**Nuclear Management Company, LLC**

Prairie Island Nuclear Generating Plant

**PRAIRIE ISLAND NUCLEAR GENERATING PLANT**

**Supplement to License Amendment Request dated December 11, 2000  
Conversion to Improved Technical Specifications (ITS)**

Figure 2.1.1-1 (page 1 of 1)  
Reactor Core Safety Limits

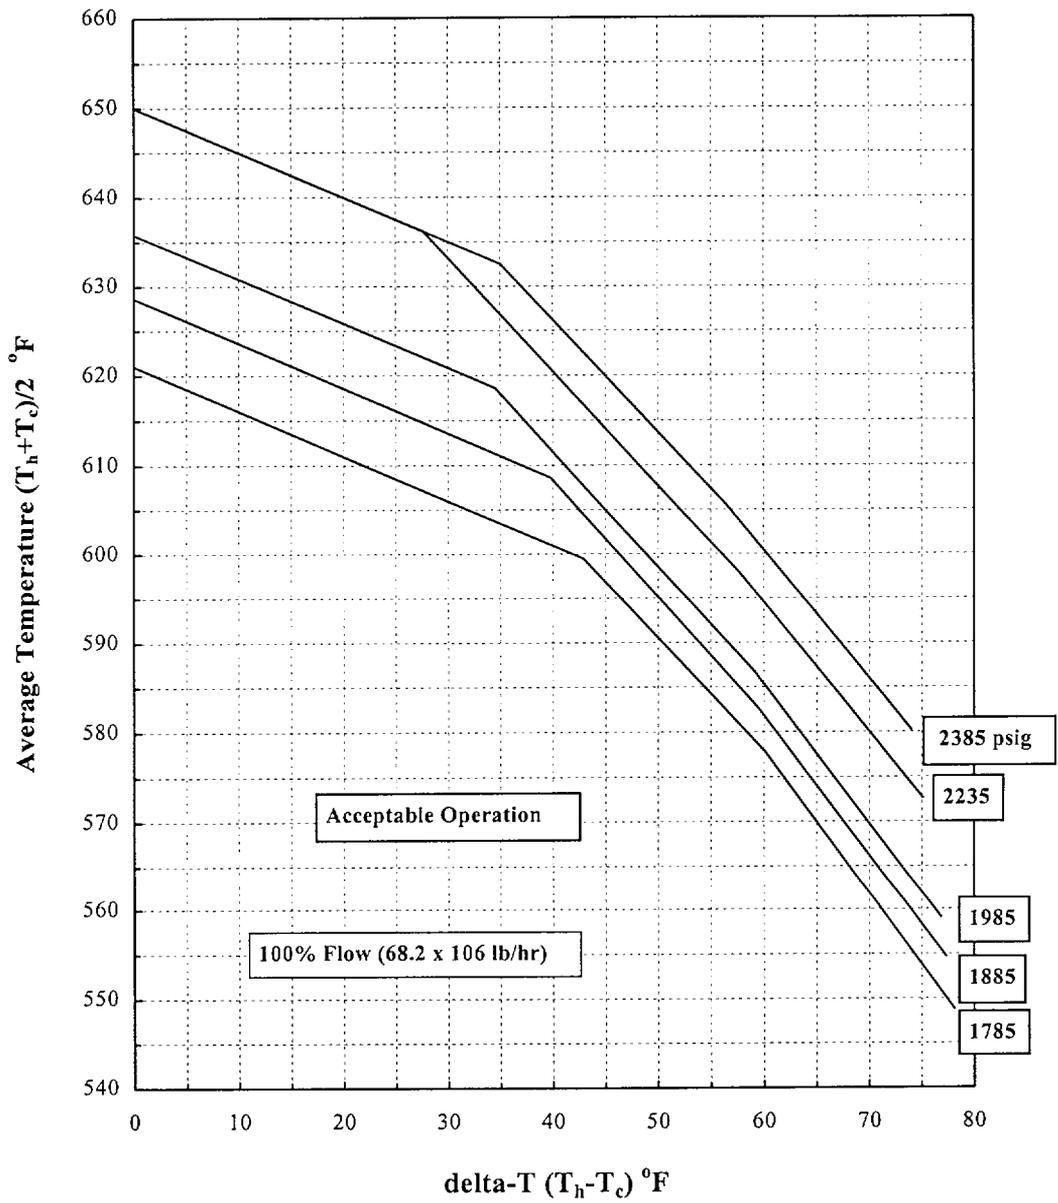
New Figure

The SL curves in Figure 2.1.1-1 define the regions of acceptable operation with respect to average temperatures, power (measured in  $\Delta T$ ), and pressurizer pressure. Each of the curves in the Figure has three slopes. For the 2235 and 2385 psig curves, at lower power (lower  $\Delta T$ ) the vessel exit design temperature, 650°F, is limiting. For the lower pressure curves, at lower  $\Delta T$ , vessel exit temperature  $T_{sat}$  is limiting, to ensure the  $\Delta T$  measurement remains valid. At all pressures after the first knee, at higher  $\Delta T$ , the minimum DNBR derived from the critical heat flux correlation is limiting. The change in slope near full power  $\Delta T$  is due to more restrictive  $F_{\Delta H}$  consideration in the DNBR limit at high power.

Figure B 2.1.1-1 (page 1 of 1)  
Reactor Core Safety Limits vs. Boundary of Protection

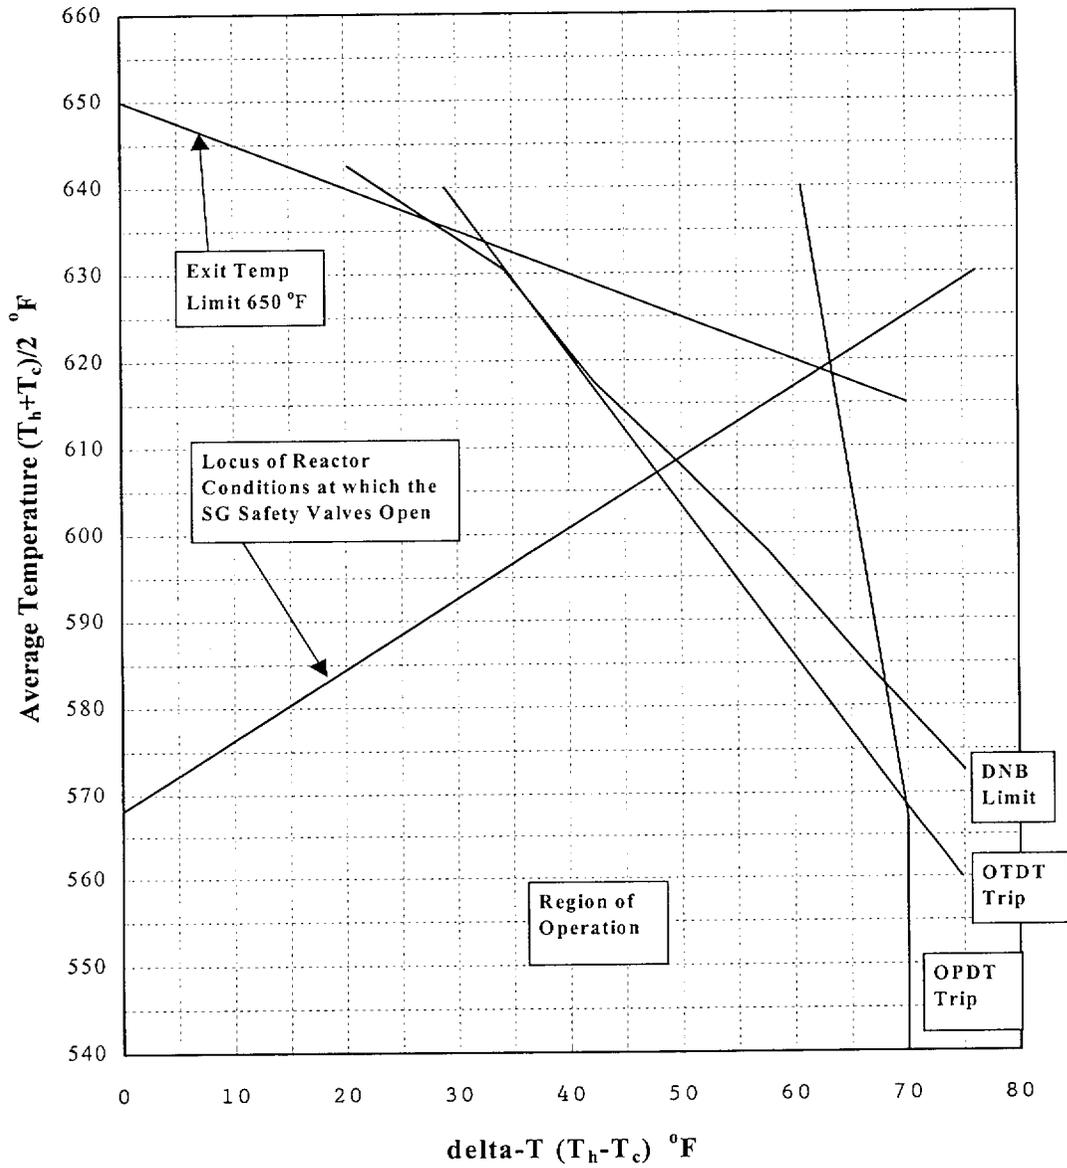
The curves provided in Figure B-2.1.1-1 show the loci of points of THERMAL POWER, RCS pressure, and average temperature for which the minimum DNBR is not less than the safety analyses limit, that fuel centerline temperature remains below melting, that the average enthalpy in the hot leg is less than or equal to the enthalpy of saturated liquid, or that the core exit quality is within the limits defined by the DNBR correlation.

The curves are based on enthalpy hot channel factor limits provided in the CORE OPERATING LIMITS REPORT (COLR). The dashed line of Figure B 2.1.1-1 shows an example of a limit curve at 2235 psig. In addition, it illustrates the various RPS functions that are designed to prevent the unit from reaching the limit.

New Figure
